Town of Casco

Planning Board Meeting Agenda

6. 960 Meadow Road Holdings, LLC. Country Village Assisted Living - Site Plan Review
– Submission in response to public comments - 960 Meadow Road, Casco ME 04015
Map/Lot 42-19

**Re: Response to Review Comments
Country Village Assisted Living Expansion
960 Meadow Road
960 Meadow Road Holdings, LLC - Applicant**

GRADING AND UTILITY PLAN

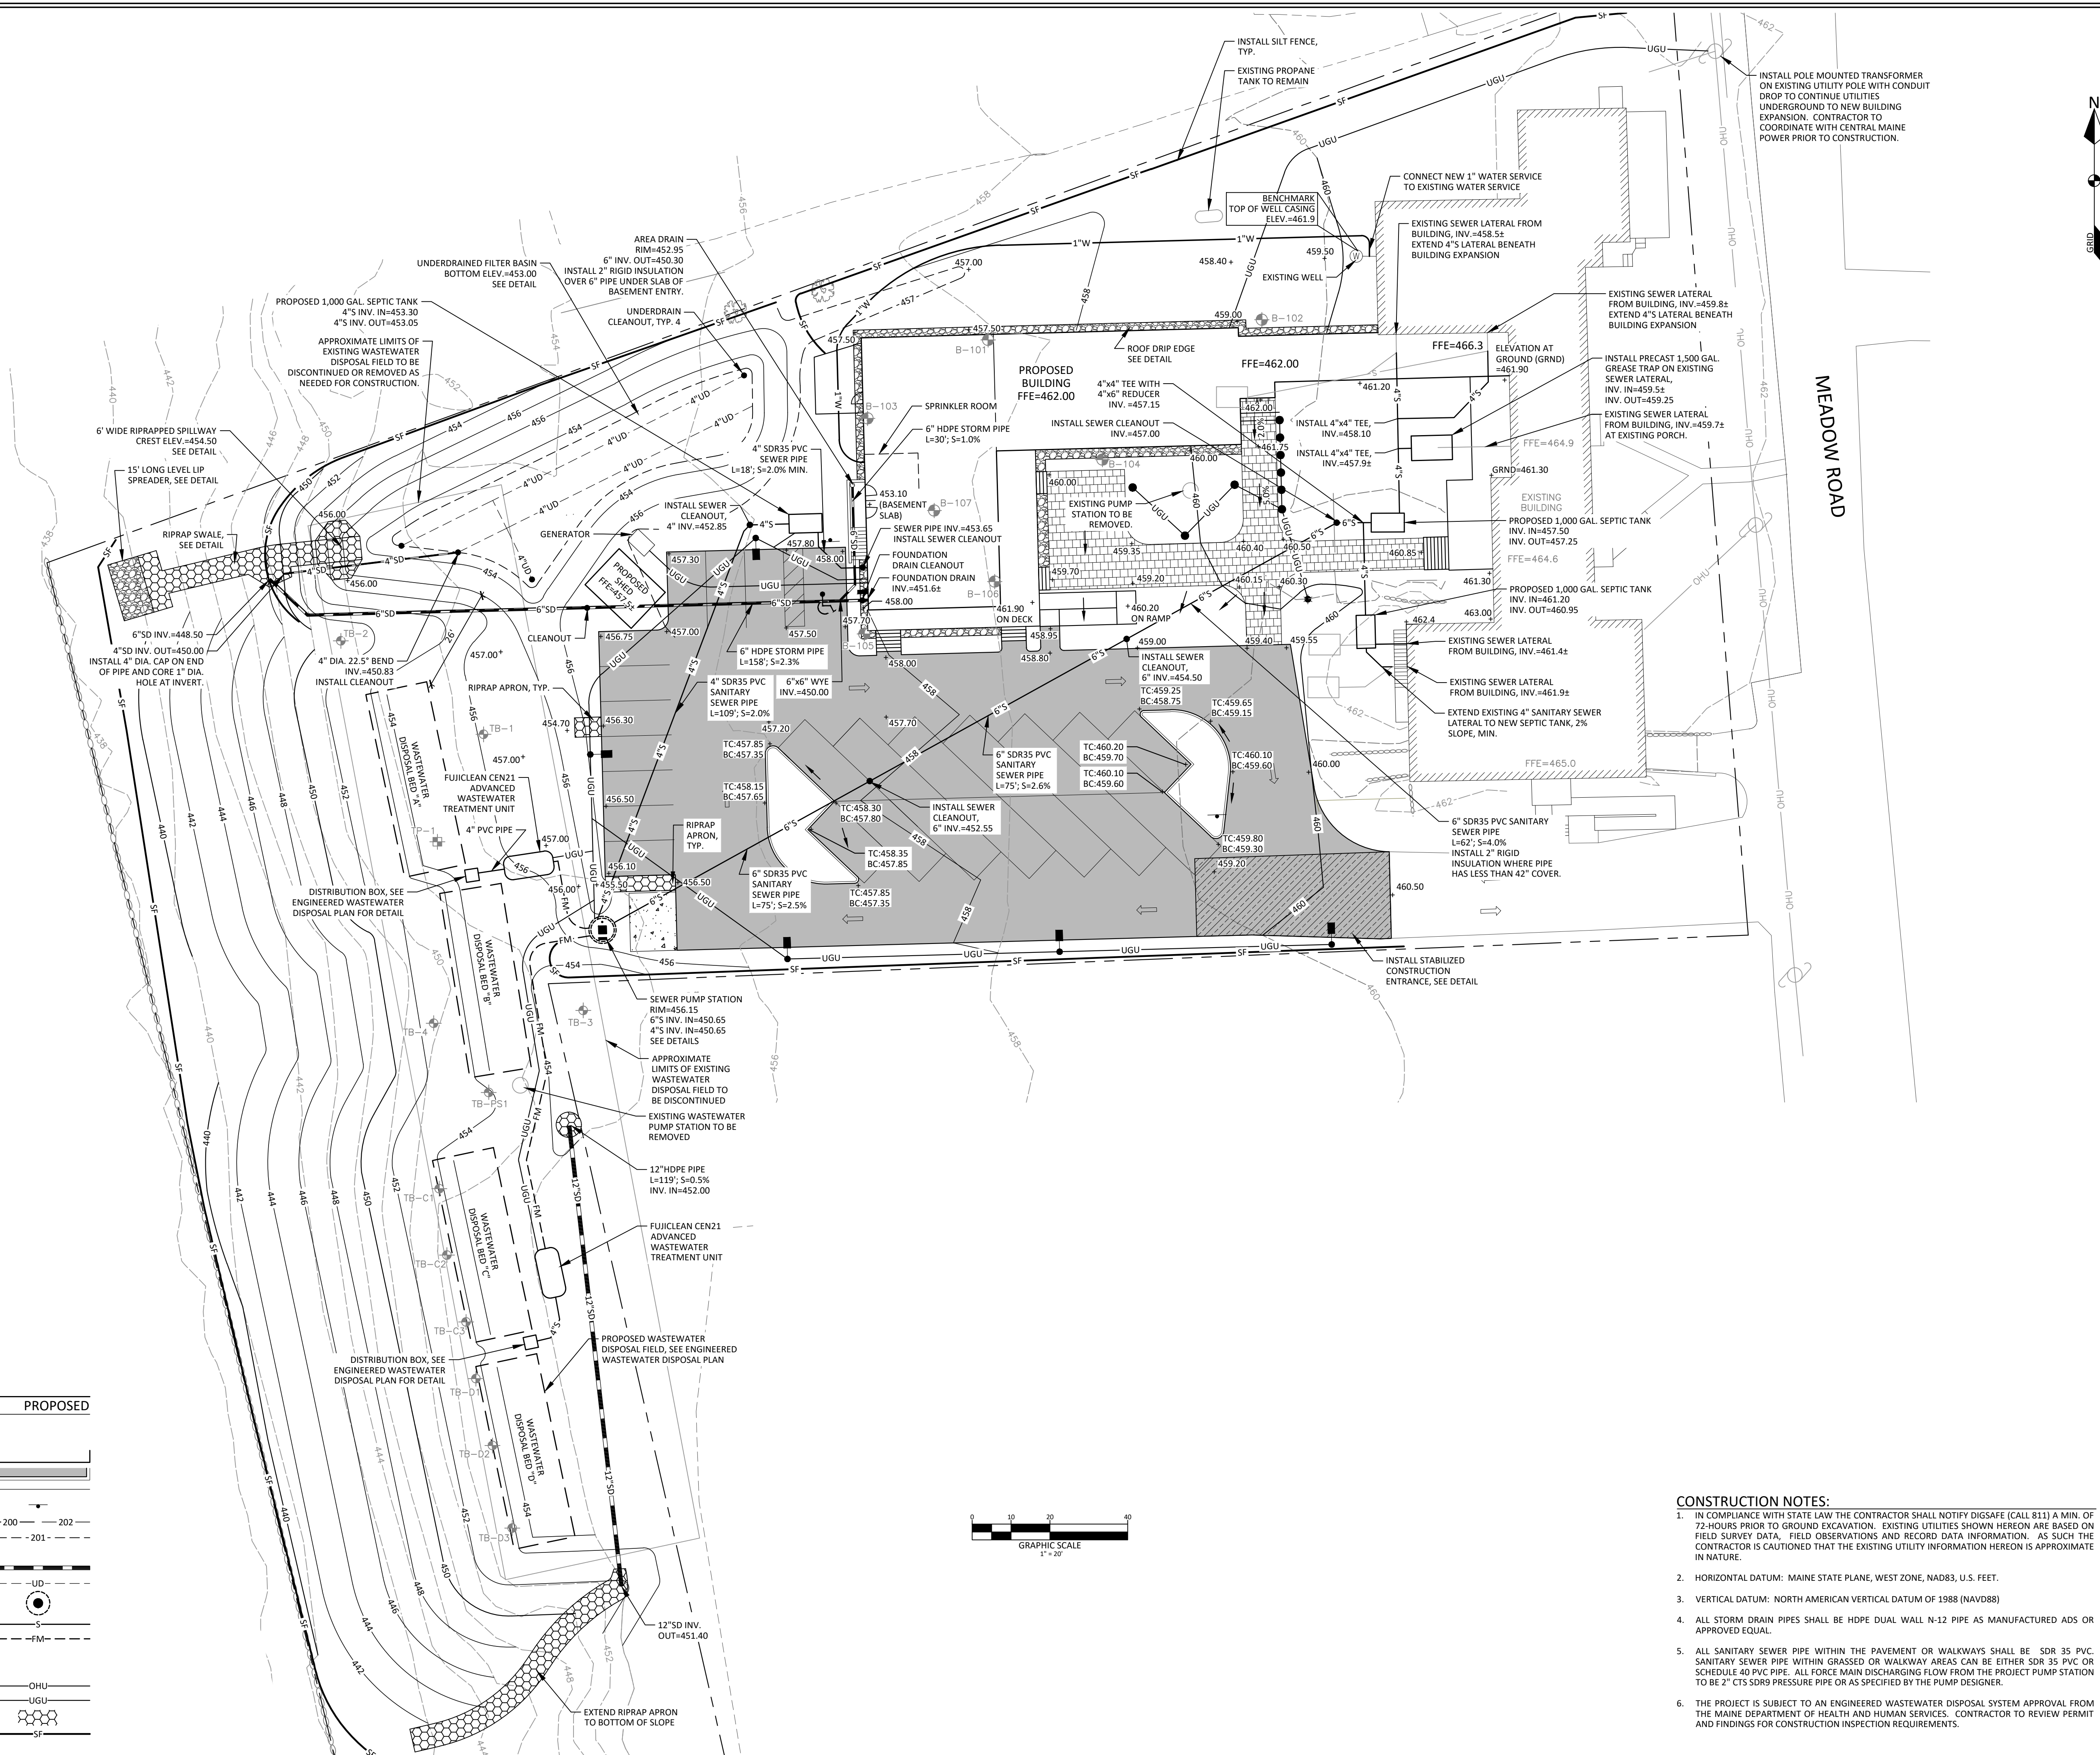
Comment 1 - Per Maine state plumbing regulations such a stormwater underdrained filtration measure shall be 25 feet from a subsurface wastewater system when the system is lined with a PVC membrane. Based on our measurements the treatment area is 22 feet measured from the proposed chamber corner to the spillway crest elevation. The pond should be shifted slightly to NW with the spillway relocated to the greatest practical extent possible.

Comment 2 - The spillway orientation spills flooding overflow directly at the end of the proposed Wastewater bed “A” before turning westerly. The distance from the runoff in a flood condition is 11-

Comment 3 - The parking lot sheet flows all runoff to the western back edge of the lot, where it appears there should be a swale to convey into the treatment filter swale. However, there is a riprap apron which tends to direct runoff over the wastewater area. There may be room for a thin swale or ditching but we have concerns that during winter months the area will become frozen and blocked by snow piles/ice and excessive melt or runoff will back up or flow into or over the wastewater system.

Response 1 – The underdrained filter basin grading has been adjusted to provide 26 feet of separation between Wastewater Disposal Bed A and the pond side of the top of berm.

Response 2 – To address the concerns, we have relocated the riprap spillway and swale closer to the north, further away from Wastewater Disposal Bed A.

Response 3 – The drainage swale was the intent of the design, but may not have been detailed appropriately. Additional spot grades have been added to the plan to indicate flow direction and depth of the swale. The riprap apron is intended to extend to the bottom of the swale and not extending toward the wastewater disposal beds.
